Subject: TRUNK LID REQUEST SWITCH INOPERATIVE - NO DTCs	Bulletin No: 09-023/07
	Last Issued: 07/05/2007

2006 - 2007 Mazdaspeed6 vehicles with VINs lower than JM1GG****7*109258 (produced before Feb. 5, 2007) equipped with Advanced Keyless System

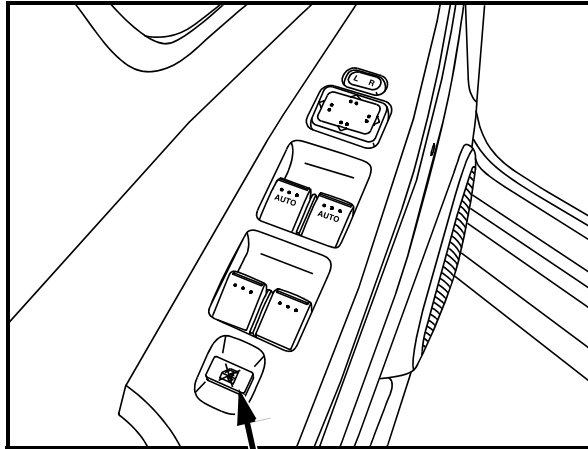
The request switch has been improved to prevent this concern by changing the sealing surface of the lead wires from a clear epoxy to a black urethane.

- If trunk lid request switch PID does not change from On/Off when pressing and releasing the request switch, and no DTC's are present, replace the trunk lid request switch according to Workshop Manual (section 09-14 REQUEST SWITCH REMOVAL/INSTALLATION).
